## DRIFTWOOD BAR & GRILL JSP17-07

Consideration at the request of Theodore Andis for approval of Preliminary Site Plan and Stormwater Management Plan. The subject property is located in Section 2 at the intersection of East Lake Drive and Fourteen Mile Road and is zoned B-3, General Business. The applicant is proposing to expand and upgrade the parking accommodations and to install a 32-seat outdoor seating area on the 1.9 acre combined parcel.

# PLAN REVIEW CENTER REPORT

**Review Date:** May 15, 2017  
**Project Name:** JSP17 – 0007: DRIFTWOOD BAR & GRILL  
**Plan Date:** May 1, 2017  
**Prepared by:** Rick Meader, Landscape Architect E-mail: [rmeader@cityofnovi.org](mailto:rmeader@cityofnovi.org);  
 Phone: (248) 735-5621

**SITE PLAN**

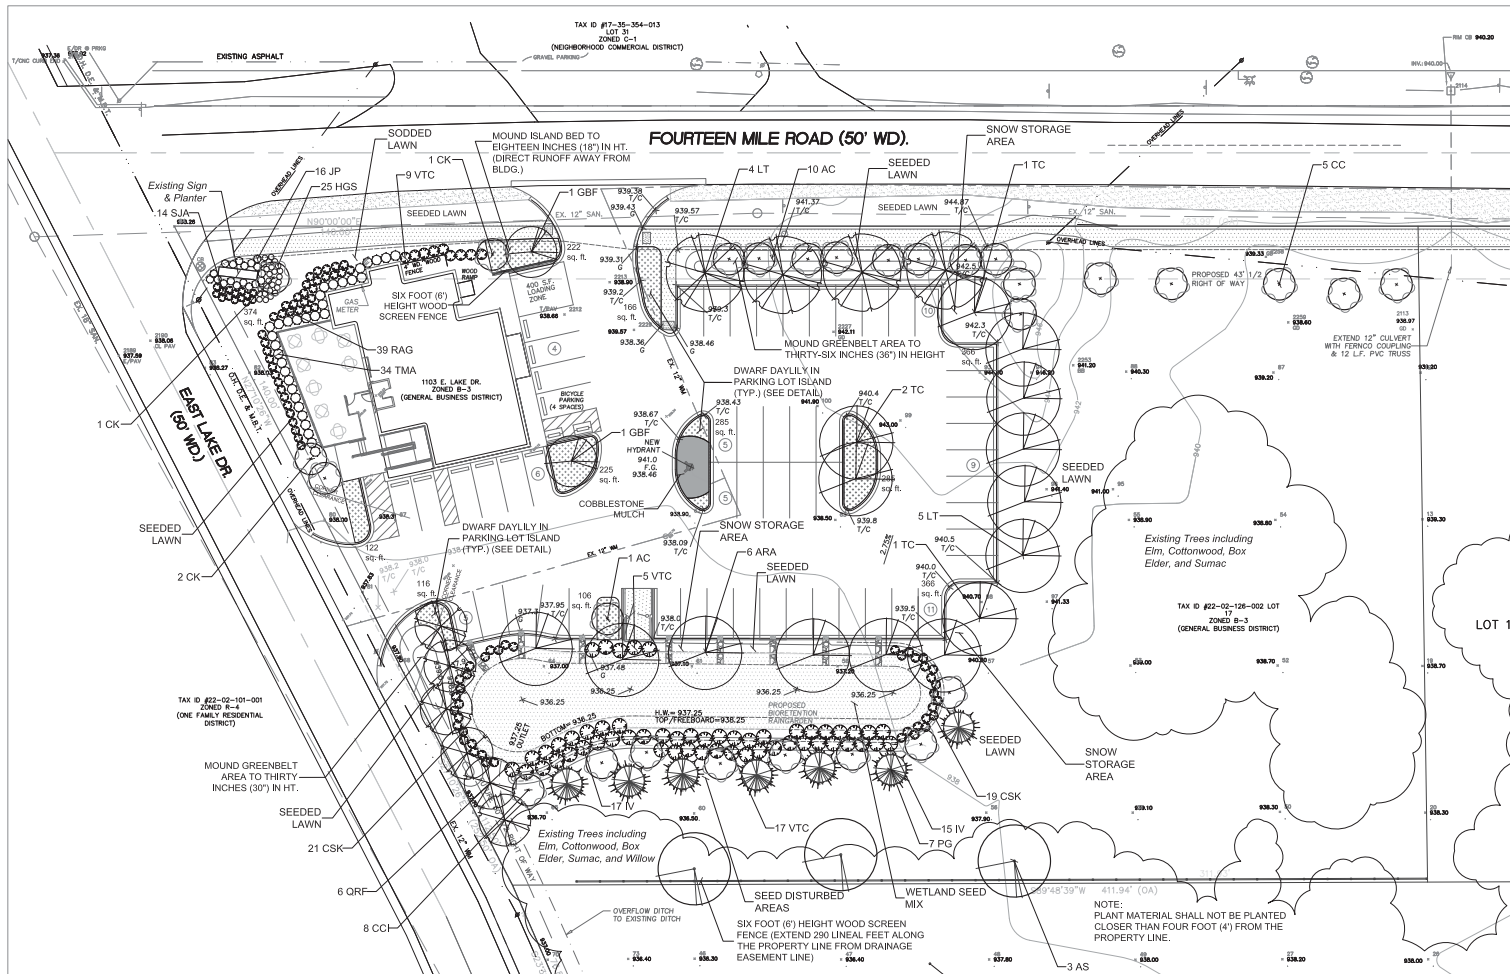
1. Parking Setback (Sec. 3.1.12.D) & Off-Street Parking in Front Yard (Sec. 3.6.2.E) & Parking Stall Located Adjacent to Parking Lot Entrance (Sec. 5.3.13): The parking on the west side of the building is within the 20 foot parking setback required by the ordinance and within 25 feet of the public ROW. **Please relocate the barrier free space and accessible lane from the 25 foot parking setback and remove one space from the southwest bay of parking to eliminate space in 25 foot public ROW setback.**

2. Parking Calculations (Sec. 5.3): Parking for restaurants is based on gross floor area or employees and customers under maximum capacity. Based on our information the customer capacity and largest number of employees on one shift would require 64 parking spaces. **The applicant should provide the largest number of employees on one shift and seating capacity for the indoor and outdoor seating areas in order to accurately calculate required minimum parking.**

4. Rooftop Units (Sec. 4.19.2.E.ii): All rooftop units shall be screened or integrated into the design and color of the building. **Please provide rooftop screening.**

5. Photometric Plan (Sec. 5.7.3): Minimum illuminations of 1.0 fc for building entrances and 0.2 fc along walkways. **Please provide the data that shows existing and/or proposed lighting near the building's main entrance and walkways on the east side and west side of the building.**

1. Provide a plan sheet detailing the existing site conditions and proposed removals.

5. Indicate the size and location of the hydrant lead extension connecting to the relocated hydrant.
6. Provide water main easement 10 feet beyond proposed hydrant location.

8. Provide calculations verifying that the proposed curb drops will be conveying storm water at non-erosive velocities (3.0 ft/s to 5.0 ft/s depending on outlet soil and vegetation type)

9. Provide a detail and sizing calculations for the proposed outlet weir.
10. Provide a soil boring log indicating that the bottom of the proposed bio retention facility is a minimum of three (3) feet above the ground water elevation in addition to the in-situ soil type(s).

13. Provide a detail for the proposed drop curbs. This detail must include the proposed means of preventing erosion and undercutting of the parking lot.
14. Variance request PDCS14-024 was approved by City Council on July 21, 2014 granting exception from the requirement to provide a bicycle path along East Lake Drive.
15. Provide a 6 foot wide sidewalk along Fourteen Mile Road west of the existing driveway. Sidewalk design and construction will require coordination with the City's plans for proposed sidewalk on Fourteen Mile Road. The plans for this public project have been provided to the applicant's design engineer.

7. Discharge rates and a comparison of pre and post volumes and rates are shown on sheet 3. The route of the storm water discharge from the bio-swale is shown.
8. Flow velocities from the spillways are shown on sheet 3. Calculations will be provided at the time of final site plan review.
9. The outlet weir and spillway sizing is shown. Calculations will be provided at the time of final site plan review.
10. A soil boring in the area of the bio-swale will be provided at the time of final site plan review.
11. Easement lines for the bio-swale will be provided.
12. The outlet swale will be redirected to the East Lake Drive culvert provided no off-site easement is necessary to do so.
